**S.16 Planning Application No. A/YL-KTS/910**
**Proposed Religious Institution (Mosque) within "Agriculture" ("AGR") Zone on the Approved Kam Tin South Outline Zoning Plan No. S/YL-KTS/15, at Lot 1542 RP (Part) in D.D. 106, Yuen Kong San Tsuen, Kam Tin, Yuen Long**
**Further Information**

**Section 16 Planning Application under the Town Planning Ordinance**
**Proposed Religious Institution (Mosque)**
**Lot 1542 RP (Part) in D.D. 106, Yuen Kong San Tsuen, Pat Heung, Yuen Long**

**Re: Section 16 Planning Application for Proposed Religious Institution (Mosque) at Lot 1542 RP (Part) in D.D. 106, Yuen Kong San Tsuen, Pat Heung, Yuen Long (Planning Application No. A/YL-KTS/910)**

**Planning Application No. A/YL-KTS/910**

**Figure 3.7 Location of the nearest bus stops in proximity to the Site**

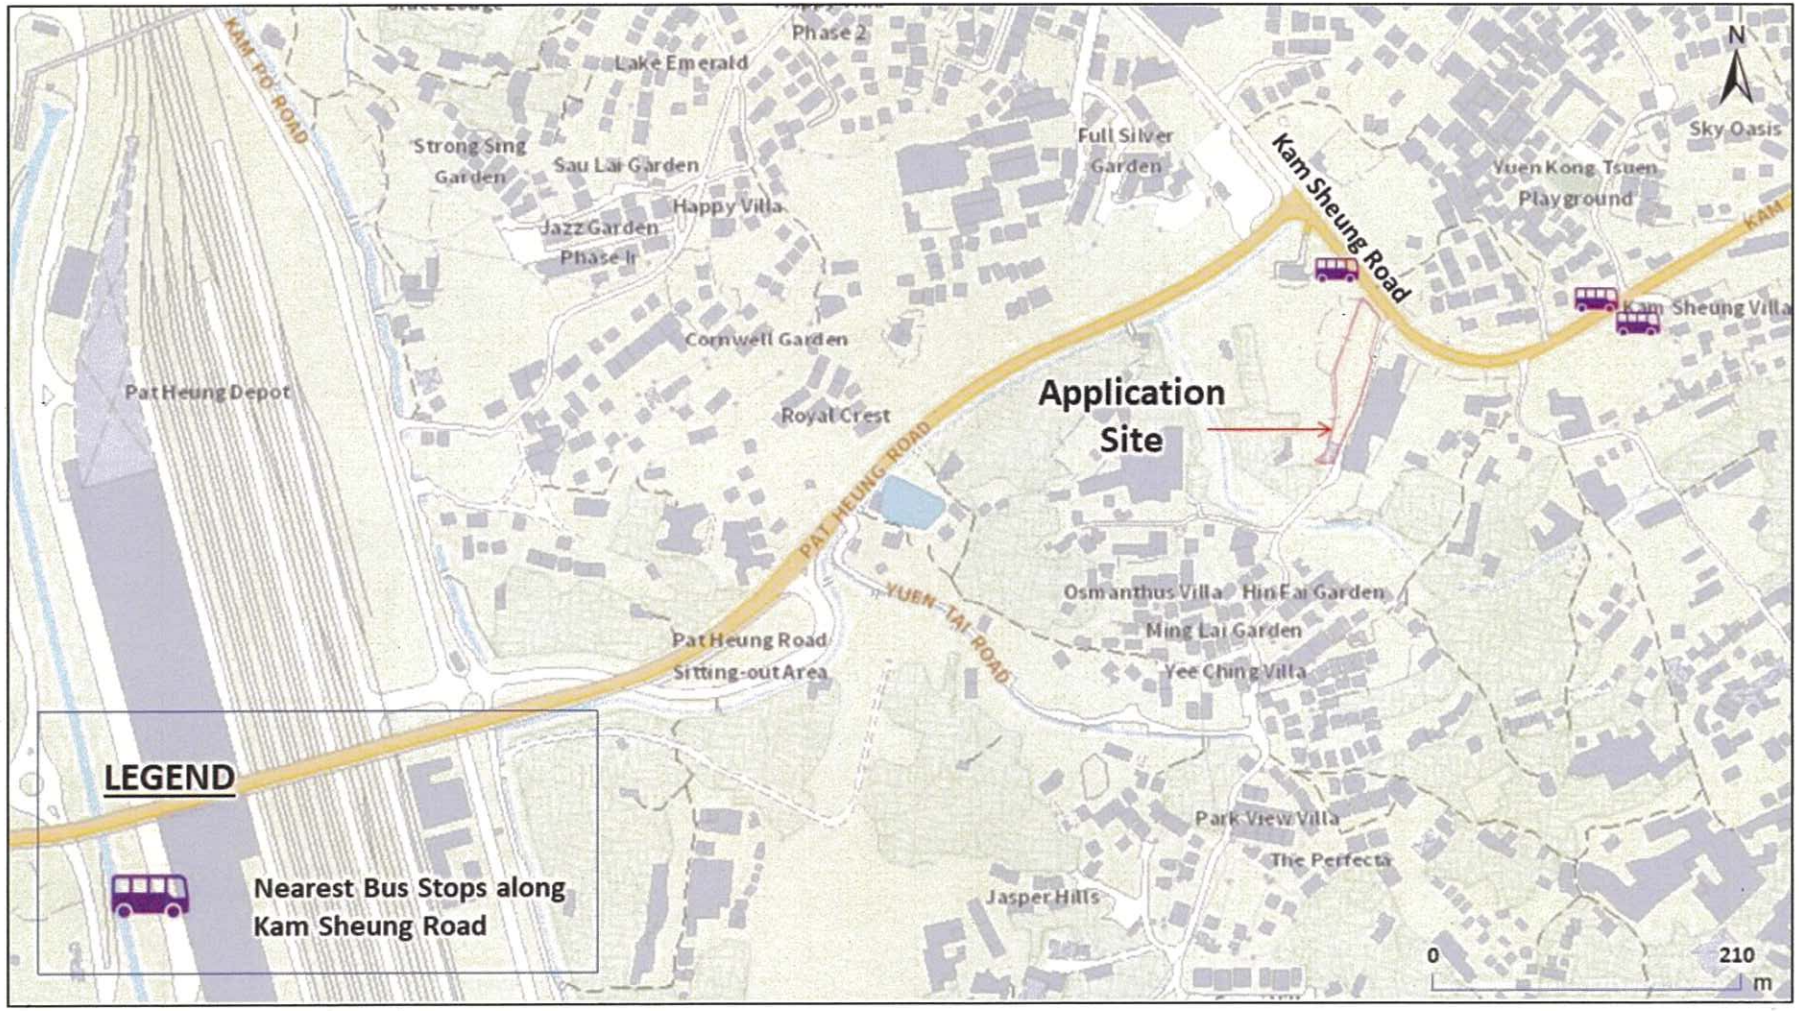
| Comments from TD | Responses by the Applicant |
|---|---|
| (f) The applicant should provide nearest public transport services and indicate on the layout plan. | The Site is directly abutting Kam Sheung Road. To minimise the traffic impact on the existing Kam Sheung Road, the future vehicular access is proposed at the local access of Yuen Kong San Tsuen off Kam Sheung Road. The north-eastern boundary of the Site is proposed to be set back as non-building area for widening of the local access road to improve the access arrangement.<br><br>The worshippers are local people/residents living and working in Kam Tin and the Site is abutting Kam Sheung Road where there are various |

| Comments from TD | Responses by the Applicant |
|---|---|
| | public transport means including buses and minibuses. As such, they will visit the Site either on foot or by public transport. Bus routes No. 64K, 64S, 251A and E36P run along Kam Sheung Road and the nearest bus stop is located one-minute walking distance from the Site, as indicated on the following plan (**Figure 3.7**). |

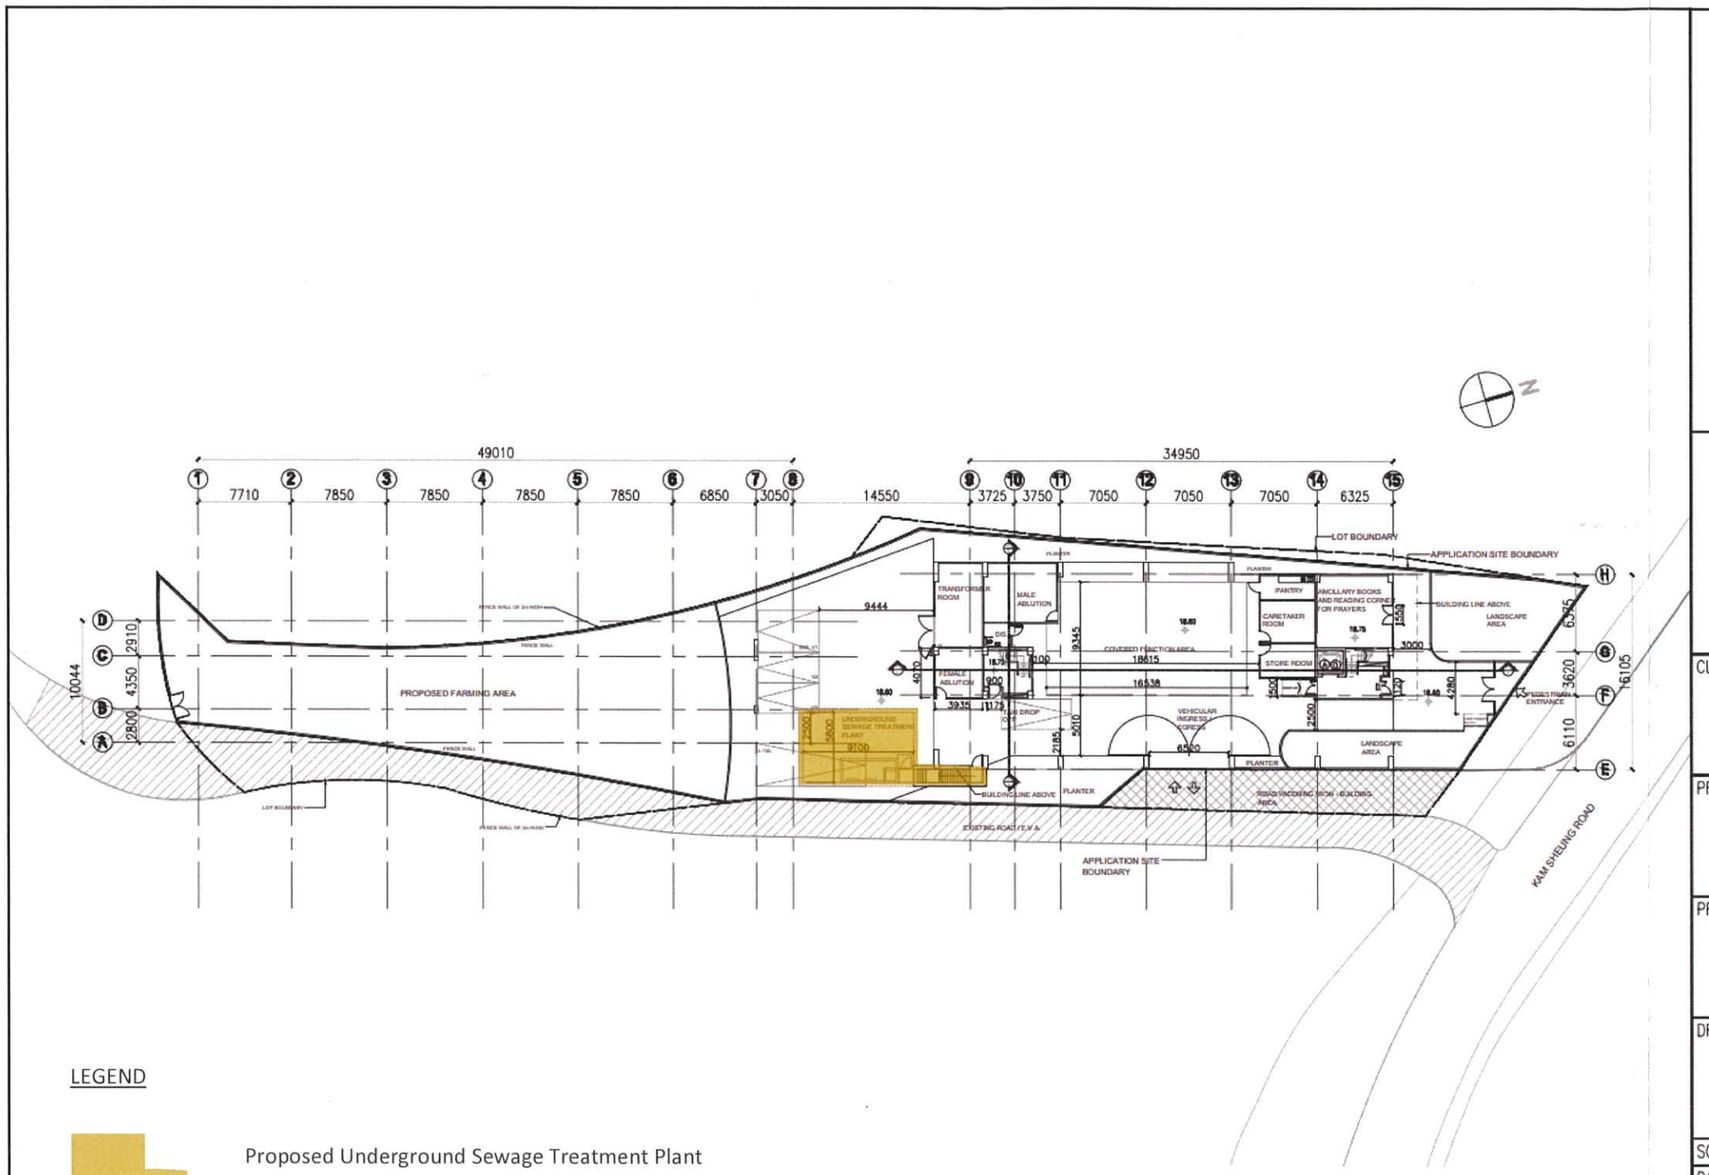
| Comments from EPD | Responses by the Applicant |
|---|---|
| 2. Appendix C Drawing RF Plan – Sprinkler & F. S. water tank pump room can be found in the drawing. The applicant should quantitatively assess the fixed noise impact associated with the Project and confirm if the designed fixed noise sources (such as on-site sewage treatment plant) of the proposed development will meet the noise criteria of Chapter 9 of HKPSG. Appropriate noise mitigation measures to alleviate the associated noise impact shall be implemented if exceedance of relevant criteria is found. | The fixed noise source associated with the sprinkler & F. S. water tank pump room will not be facing the nearby sensitive receivers and the sewage treatment plant is underground in enclosed structures. It will be designed to meet the relevant noise standards in Chapter 9 of the HKPSG. The applicant is willing to accept an approval condition on the above if necessary. |

# UNDERGROUND SEWAGE TREATMENT PLANT ROOM LAYOUT PLAN (OPTION 2)

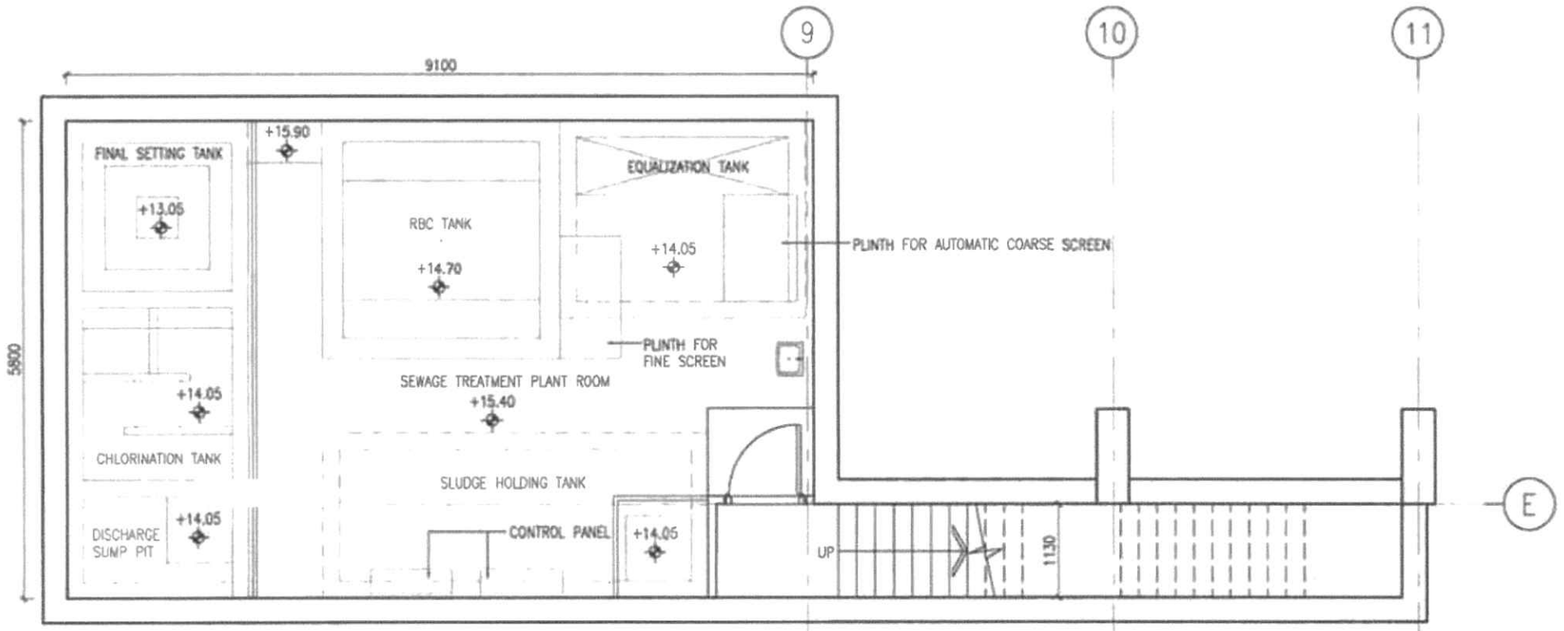
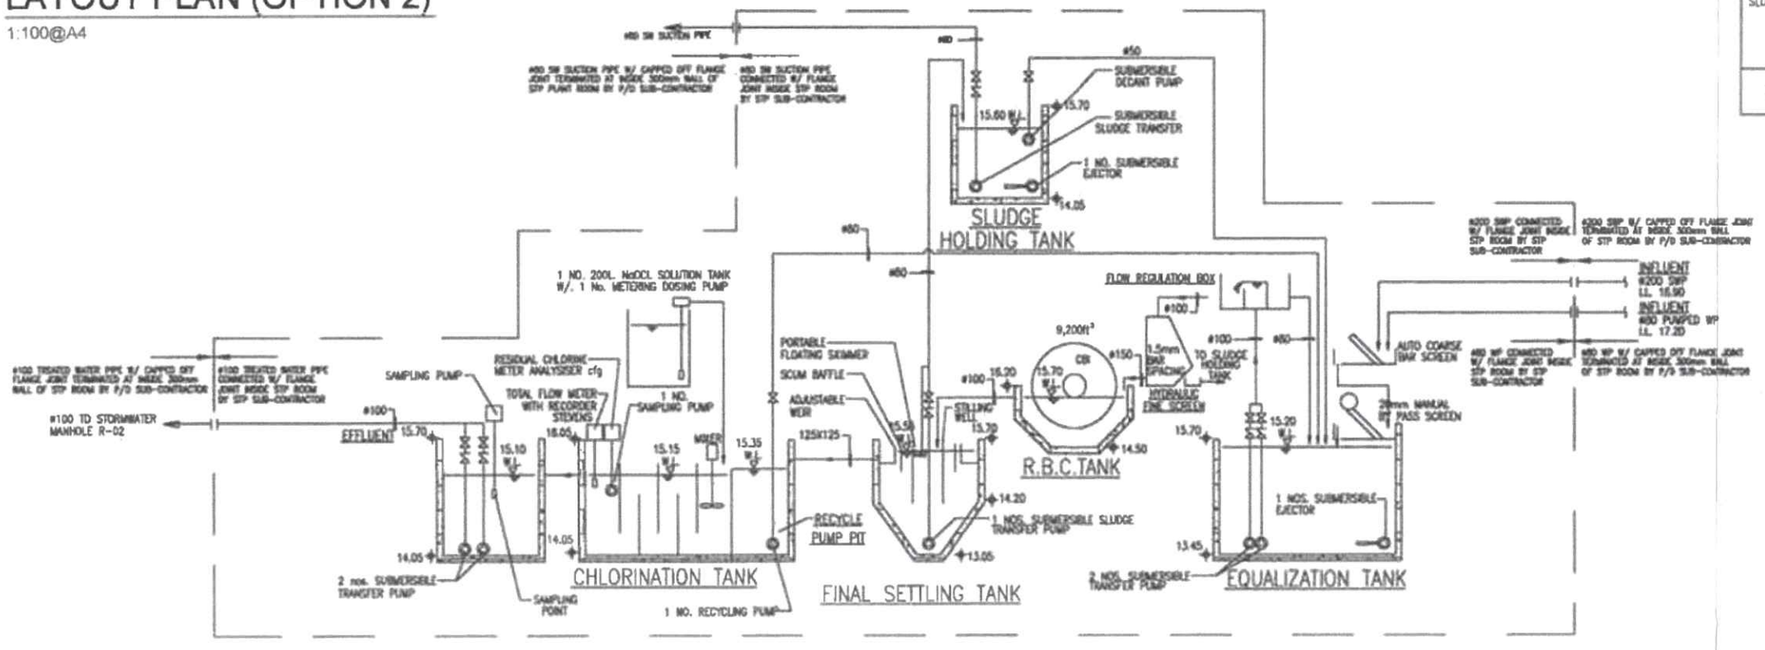
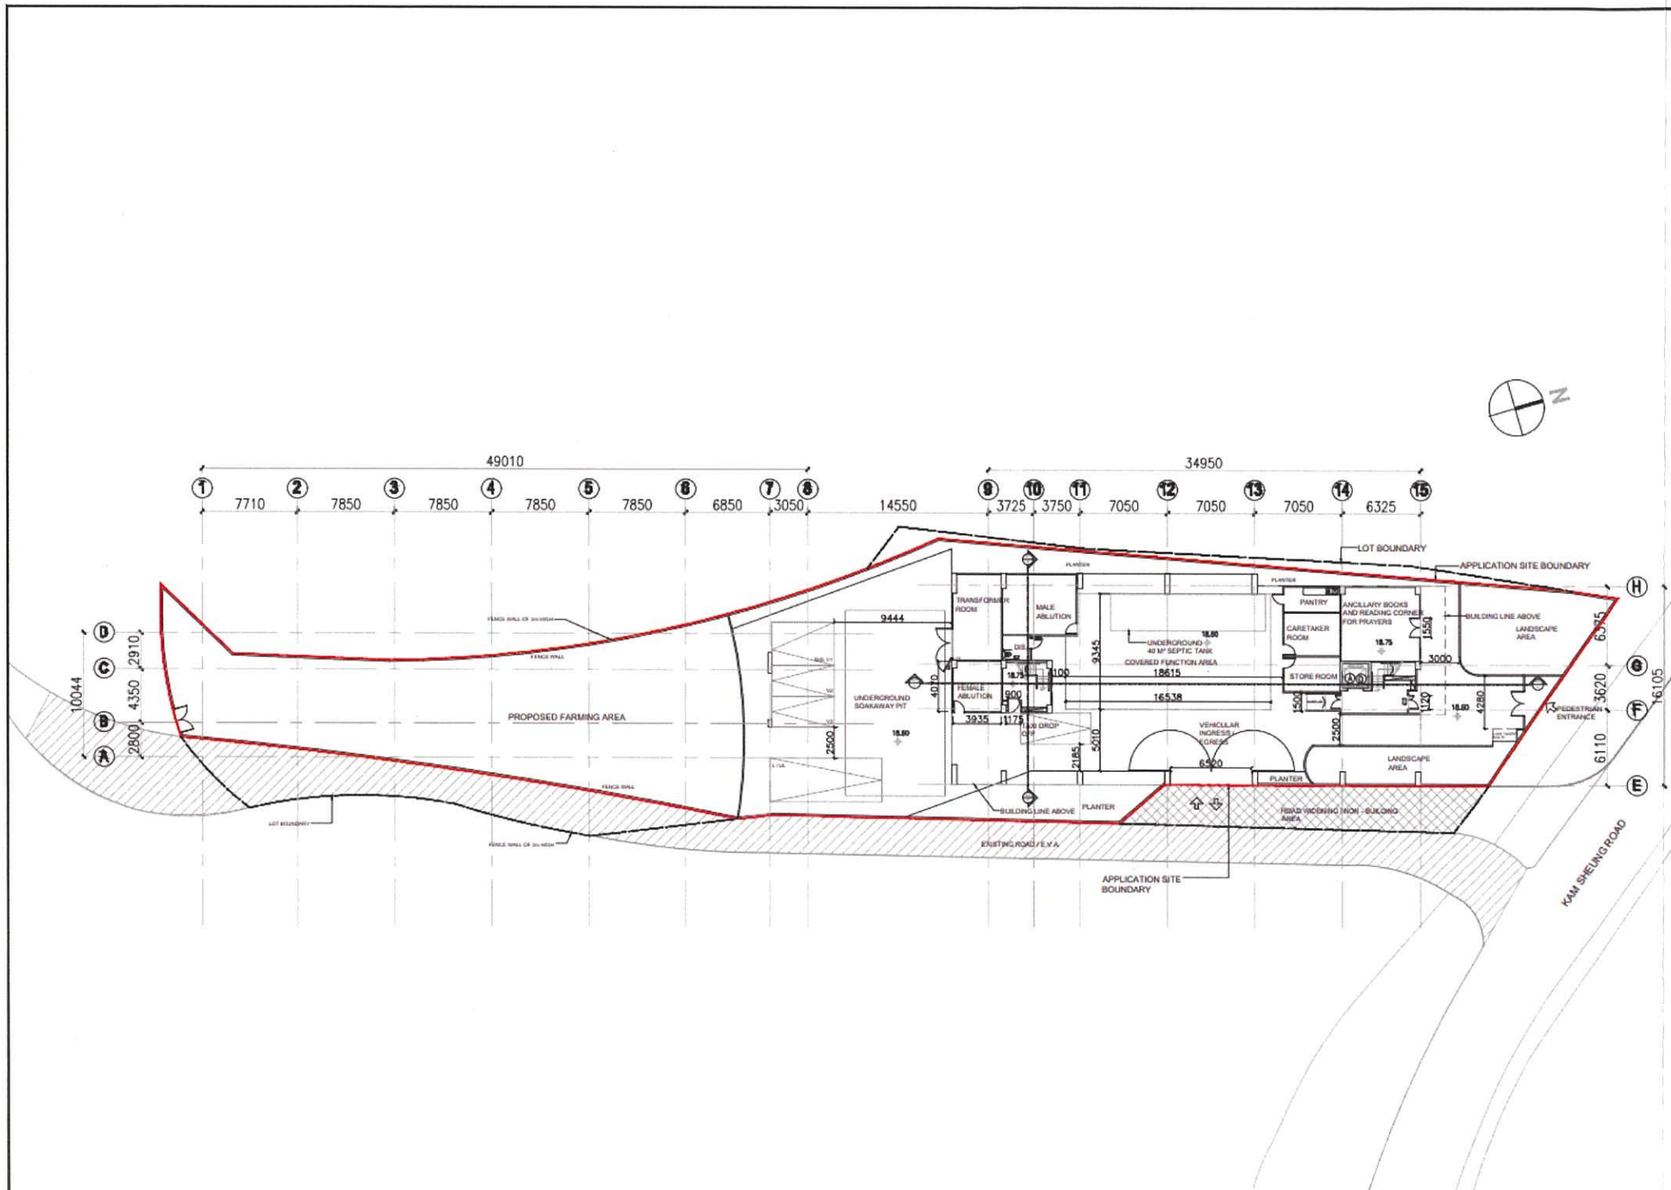
</table>
* Depending on the waterbody receiving the discharge, the more stringent set of the effluent standards (those listed in the above table or the WPCO TM) should be adopted as appropriate.<br><br>
Please provide basic information of the on-site sewage treatment plant to demonstrate that such system is capable of handling sewage generated without causing adverse water quality impact. The basic information shall at least include: expected quantity of sewage generated, technology of sewage treatment plant, point of effluent discharge, measures to avoid adverse impact
</td><td>
There is no public foul water/sewerage system serving the surrounding area. The proposed development will utilise a small sewage treatment plant or septic tank/soakaway system on site, which will be designed in compliance with EPD's requirements. Regular cleaning and maintenance inspections will be carried out by the owner to ensure proper and smooth operation of the on-site sewage facilities. The proposals for the above sewerage system options, i.e. a small sewage treatment plant and septic tank/soakaway system are set out below.<br><br>

These sewage treatment options are both feasible for incorporation in the proposed mosque development, and for demonstrating that the proposed development would not generate adverse sewerage impact on the surrounding area. The details on which will be finalised at the approval conditions compliance stage and general building plan submission. Detailed assessment will be carried out when designing the proposed sewerage system taking into consideration whether public sewer will be extended to the Site or not at the detailed design stage.
</td></tr>
</table>

**Option 2: Septic Tank & Soakaway System (the layout is same as that submitted to the TPB on 30.9.2021)**

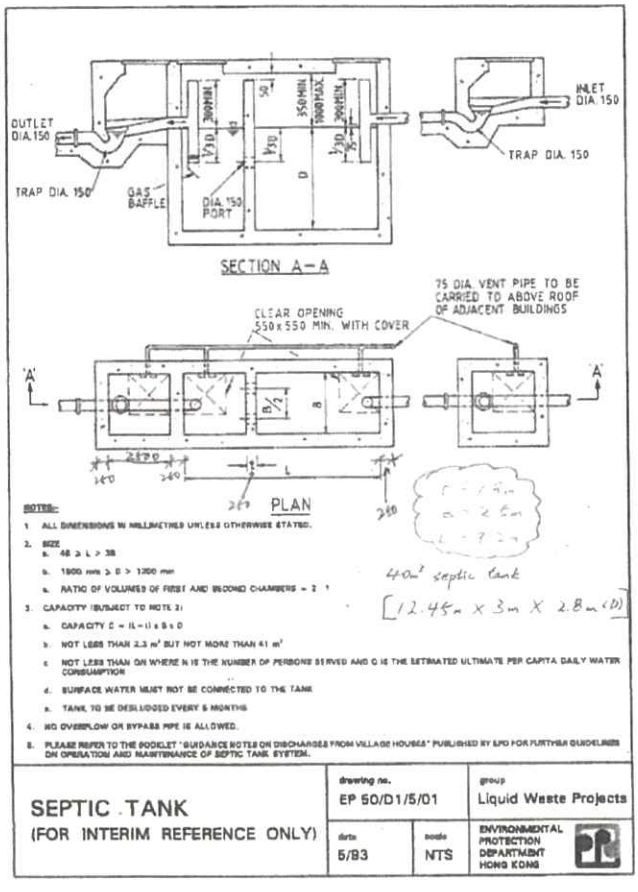
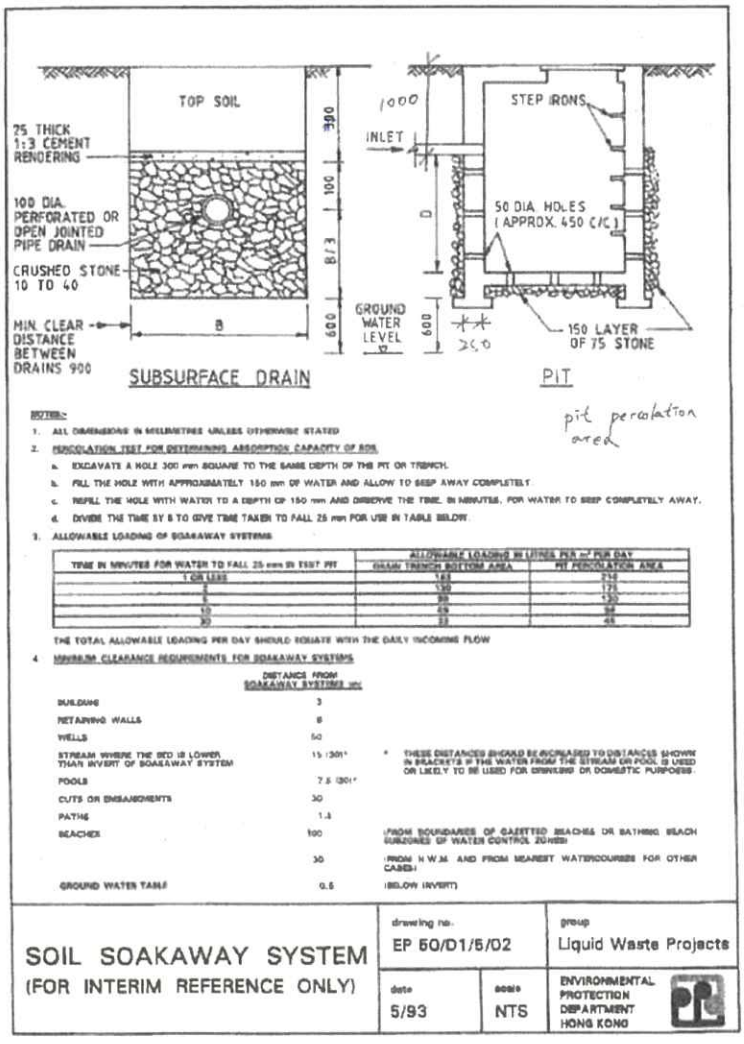
| Date | Department | Comments | Response to Comments |
|---|---|---|---|
| | | (ii) Location of septic tank system: The applicant has not conducted soil percolation test and the size of the soakaway system is based on an assumption using the highest allowable loading (i.e. 216L/$m^3$d and 163L/$m^2$d) according to ProPECC PN5/93 "Drainage Plans subject to Comment by the Environmental Protection Department". The actual percolation test result may be different with a much bigger soakaway area required | More information including ground investigation will be available during the detailed design stage. Therefore, the location of the proposed septic tank/soakaway pit system will be reviewed during the detailed design stage with reference to ProPECC PN5/93. |

(iii) The actual soil absorption capacity will be determined on site in accordance with the Soil Percolation Test for Soakaway Design under Appendix 2 of EPD's Guidelines for the Design of Small Sewage Treatment Plants. It is understood that the adequacy of septic tank and soakaway system will be subject to the actual amount of sewage generated from the proposed mosque. **Upon approval by the TPB, the applicant will address the above at the detailed design stage.**
